RE: PRELIMINARY PLAN APPROVAL FOR ADDITIONAL LUBRICATING OIL TANKAGE  
CHEVRON CANADA LIMITED

TO: MUNICIPAL MANAGER 1979 SEPTEMBER 12  
FROM: DIRECTOR OF PLANNING  
SUBJECT: CHEVRON CANADA LIMITED — PRELIMINARY PLAN APPROVAL APPLICATION  
ADDITIONAL LUBRICATING OIL TANKAGE

The Planning Department is in receipt of an application (Preliminary Plan Approval Application Number 5190) from Chevron Canada Limited for installation of eight small additional storage tanks at the Chevron Refinery site, 355 N. Willingdon Avenue. The location and relative size of these tanks is indicated on the attached sketches.

PERMIT DRAWING  
 1979 LUBE OIL TANKAGE ADDITION

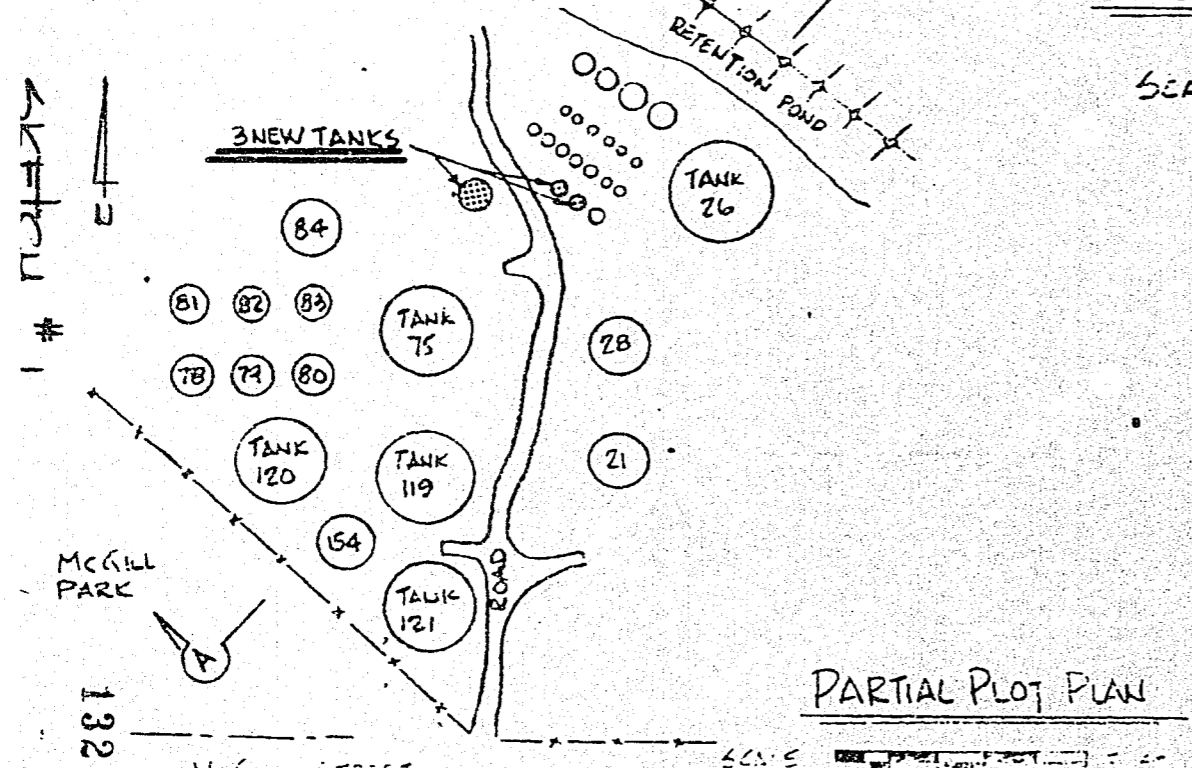
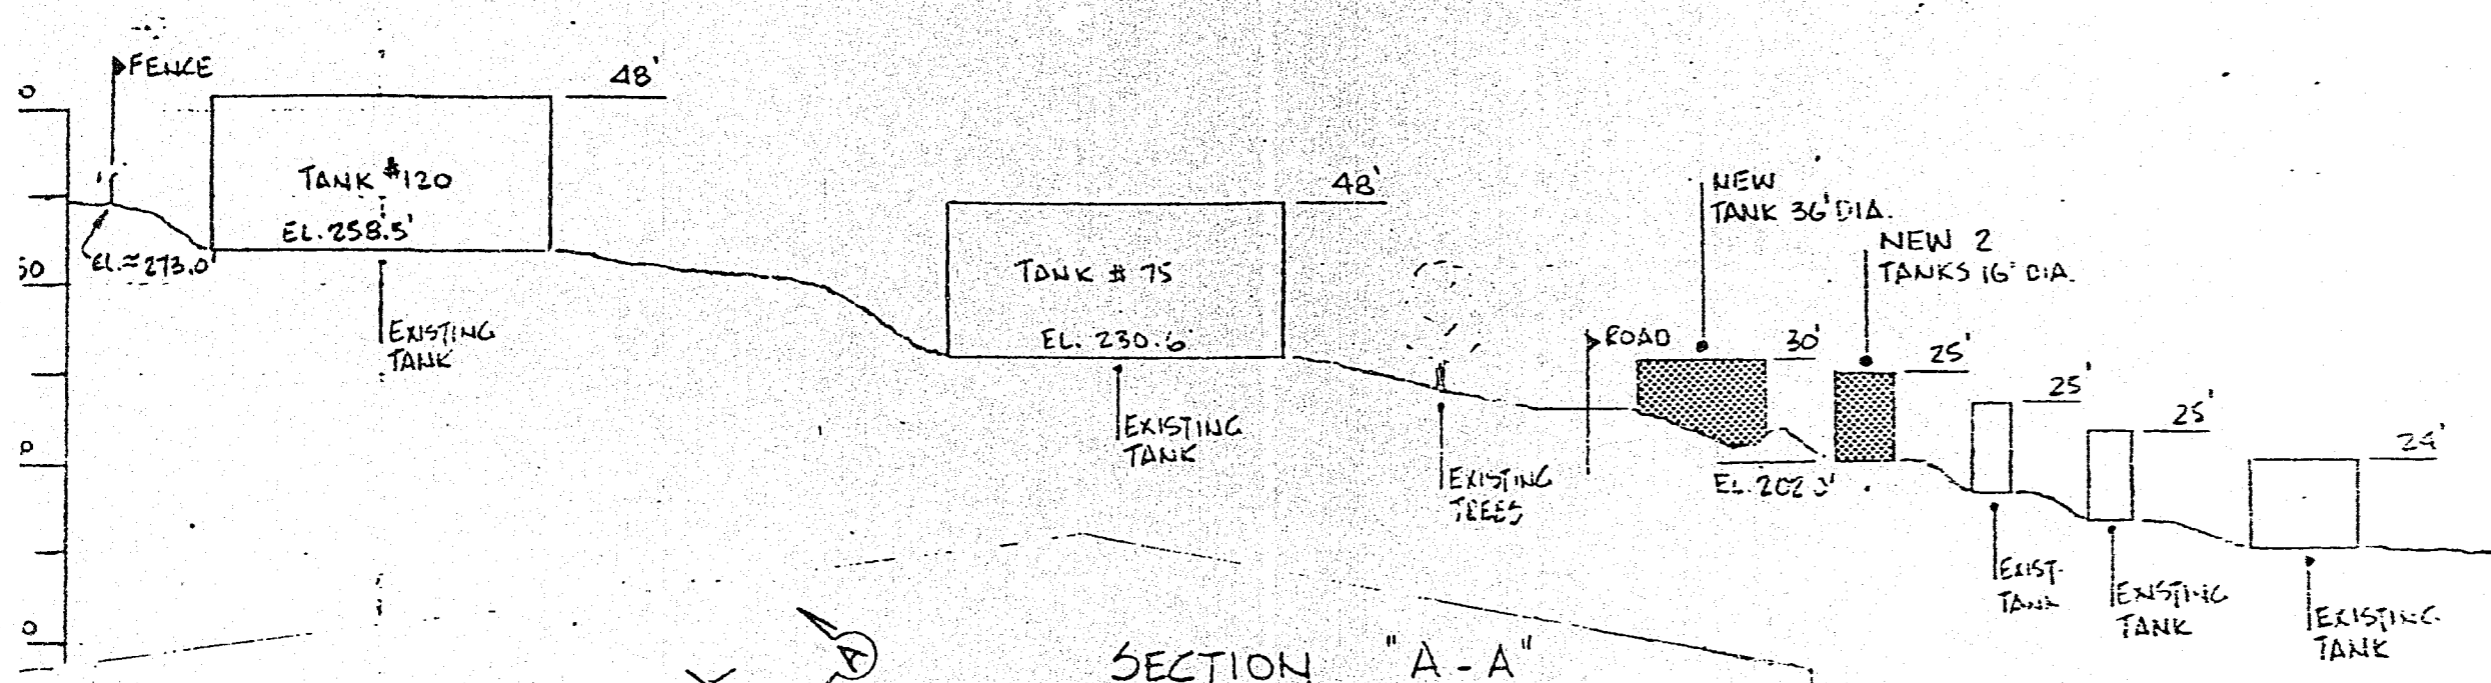
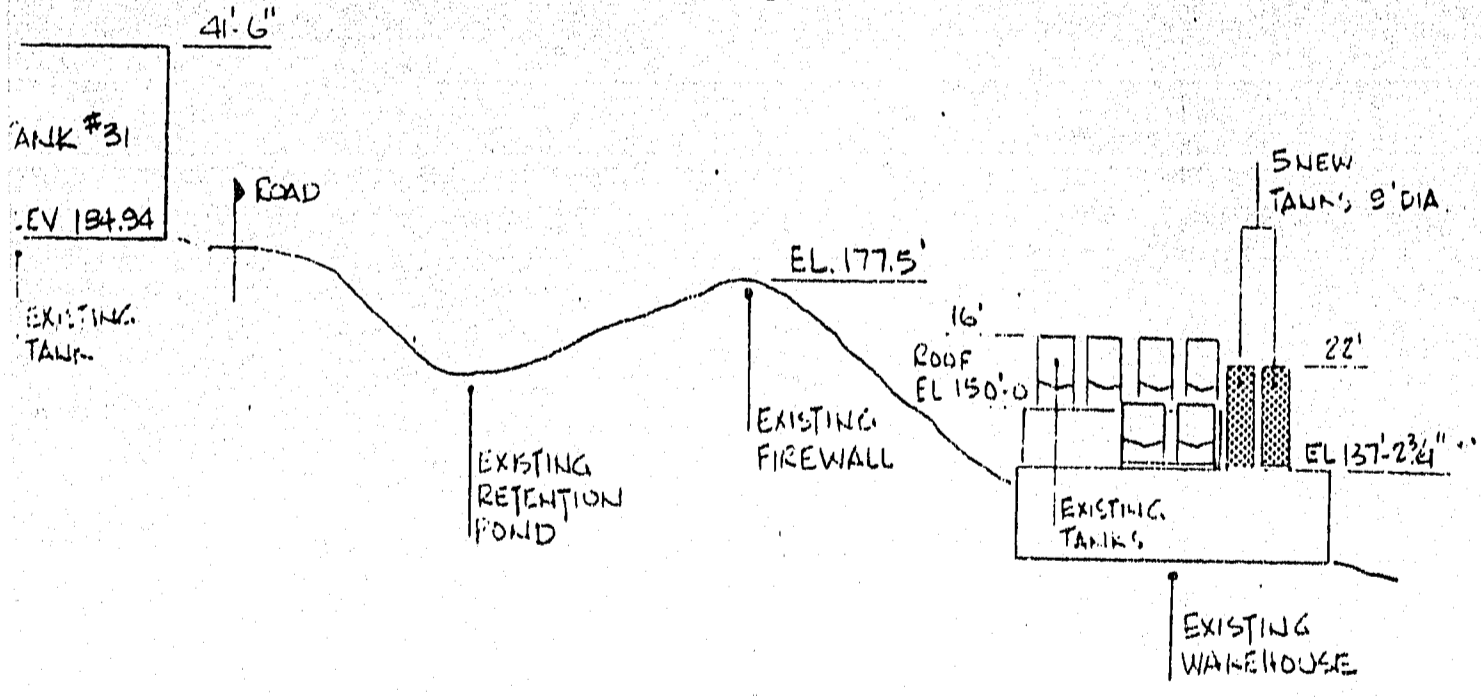
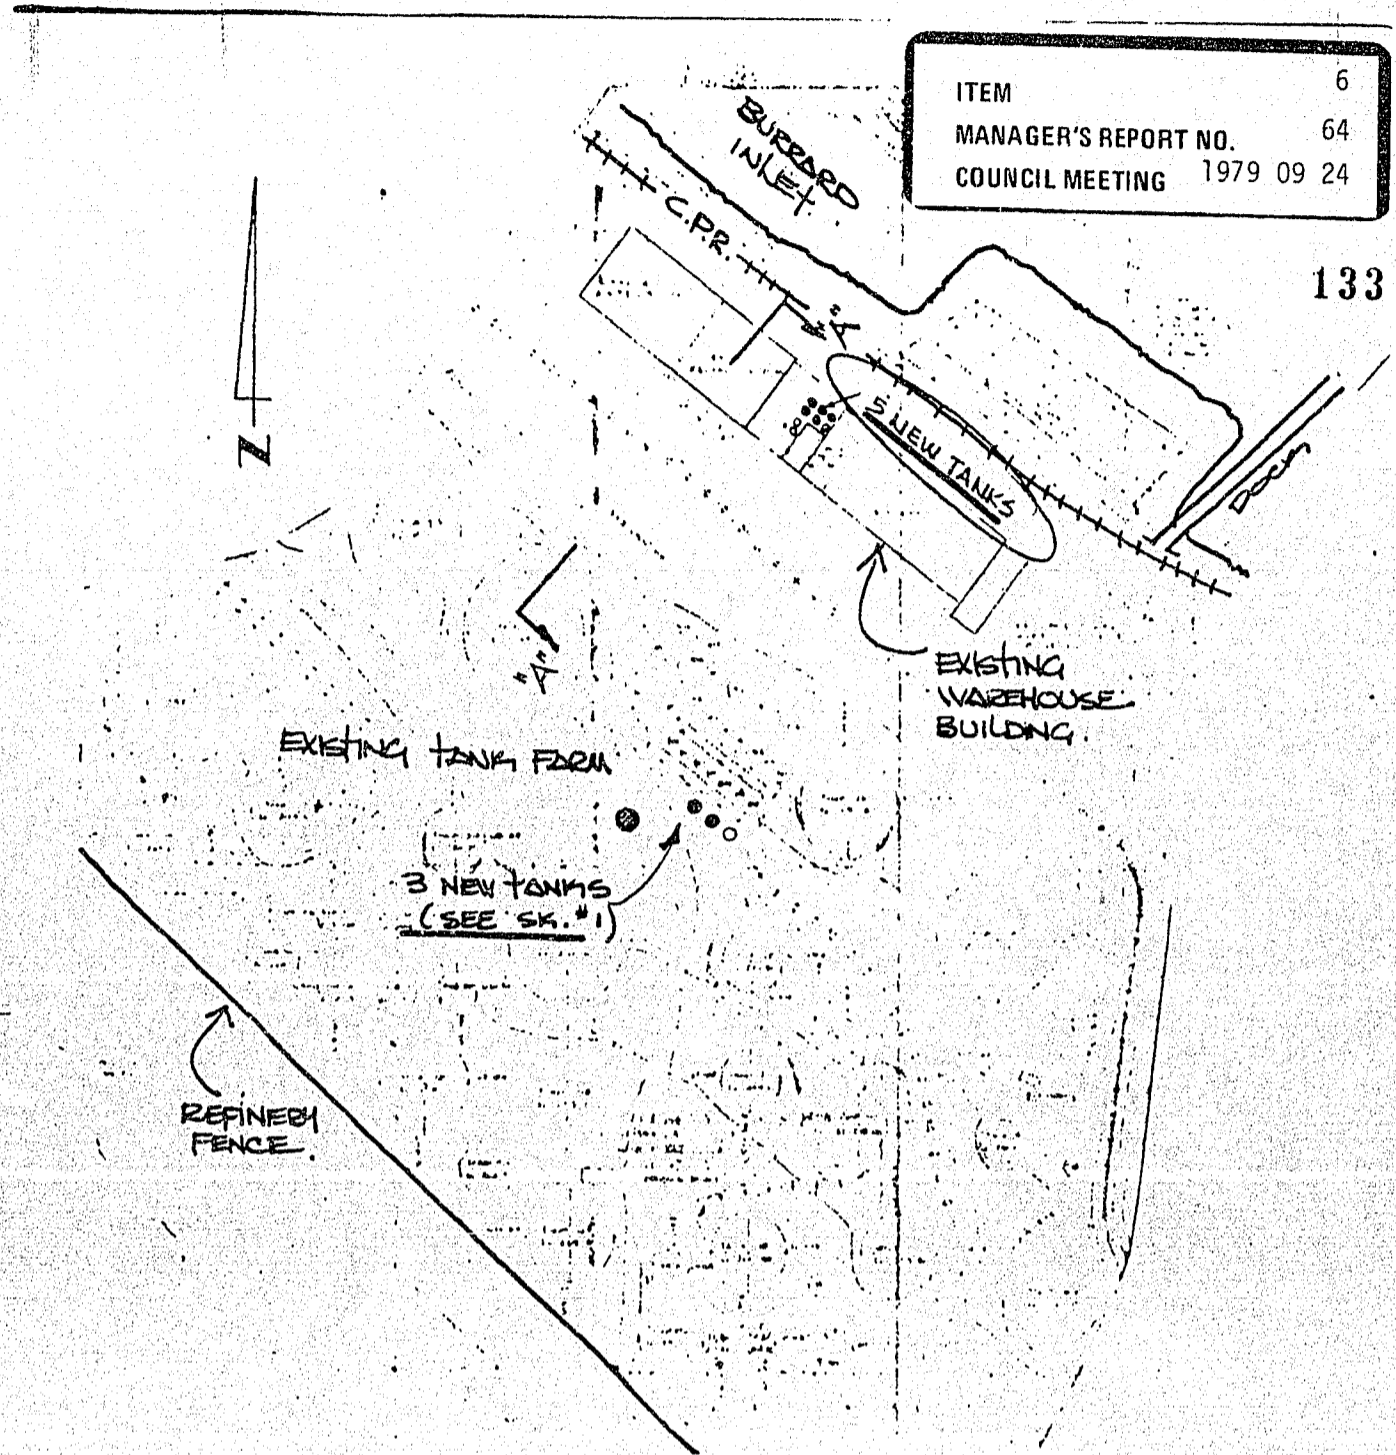
In terms of location and environmental impact, the eight new tanks now being proposed are situated in the lower regions of the existing tank farm area, at elevations considerably below the ground level of the southern boundary of the tank farm site and in locations virtually completely screened from view in the residential area by existing installations (see attached Sketches 1 and 2). The proposed new tanks are to be situated in an orderly fashion in areas presently typified by rows of small scale product tanks, and as a result are consistent with the geometry and scale of their location.

Inasmuch as the proposed new tanks are not considered to have adverse environmental impact on the surrounding neighbourhood, as they are within the lower, northerly reaches of the site and are being arranged in an orderly fashion which should not be offensive in terms of views from the vantage points from the north, and as their installation will not, according to Chevron officials, contribute to increase in the through-put capacity of the refinery, this Department would propose to issue Preliminary Plan Approval No. 5190 subject to compliance with the by-laws, unless otherwise directed by Council.
